AGENDA PORTLAND PLANNING BOARD MEETING

Memorandum
Planning and Urban Development Department
Planning Division

To: Brandon Mazer, Chair and Members of the Portland Planning Board
From: Andrew Tufts, Planner
Date: June 9, 2020
Re: Fallbrook Commons, 60 Merrymeeting Drive, Fallbrook Commons Development LLC
Project #: PL-000925-2019 CBL: 400 Do23
Meeting: June 9, 2020

3 DRIVEWAY APRON WITH PEDESTRIAN ACCESS ROUTE - FIGURE I-9A

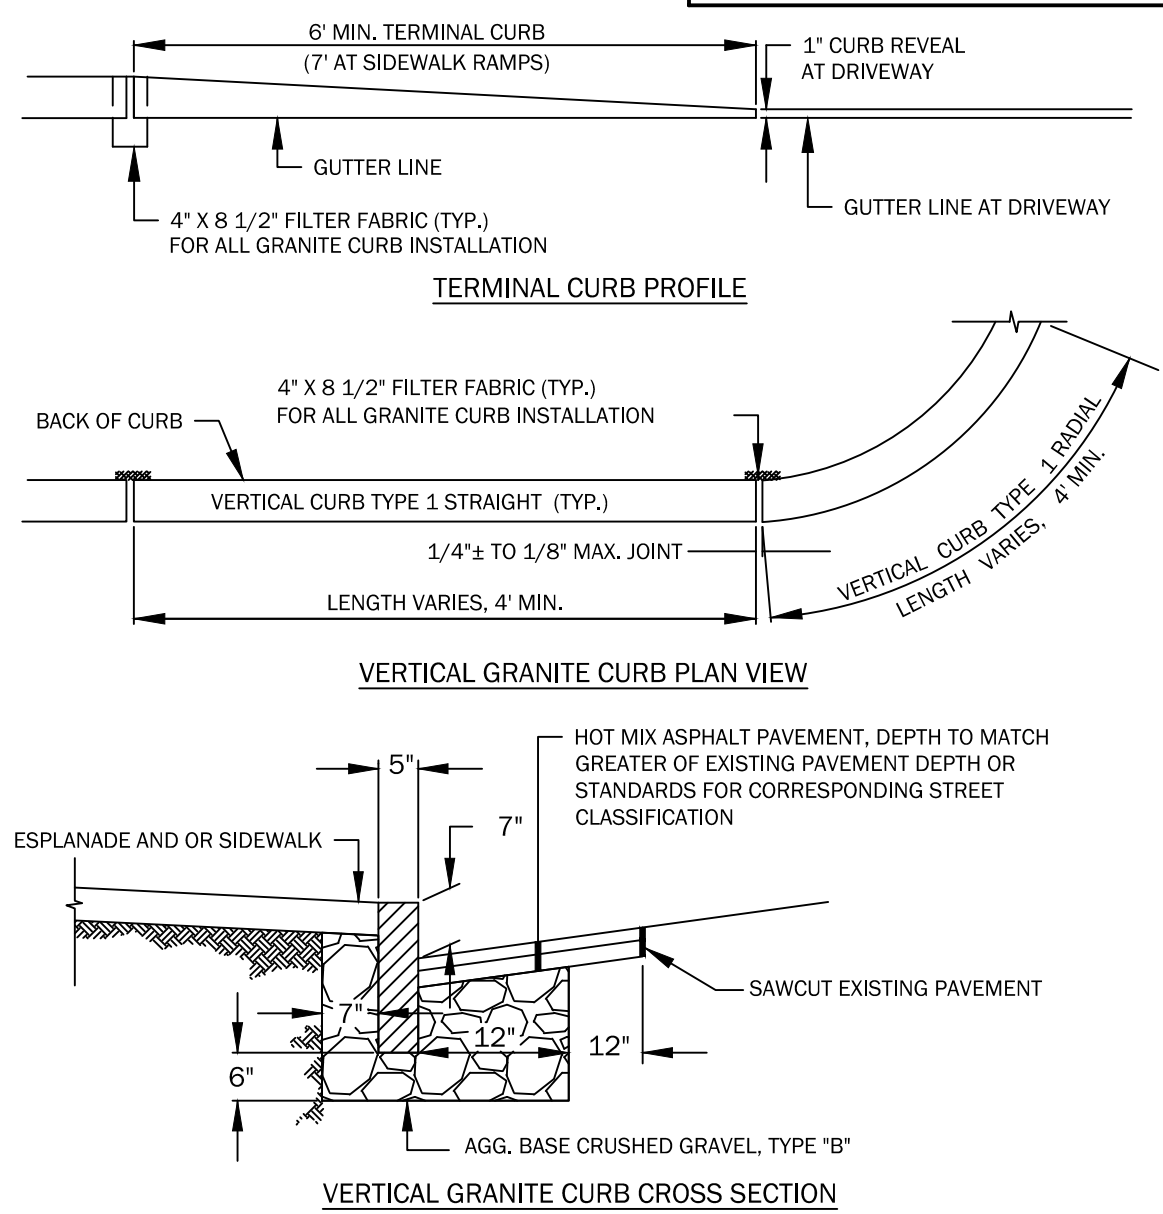
- The driveway apron layout provided in the details should be replaced with a detail that shows proper ADA compliance. I have attached two figures; Figure I-9A, where the sidewalk does not ramp down to street level, is is preferable. Note that the proper sidewalk material is concrete for Stevens Avenue and bituminous for Bishop Street, as correctly noted in the site plan.

The driveway aprons have been adjusted to comply with City Detail I-9A. Detail 3 on Sheet C3.2 (Detail I-9) has been replaced with I-9A.

Per Transportation Associated Comment #8 The driveway aprons have been adjusted to comply with City Detail I-9A. Detail 3 on Sheet C3.2 (Detail I-9) has been replaced with I-9A. Additional detail is added to the plan.
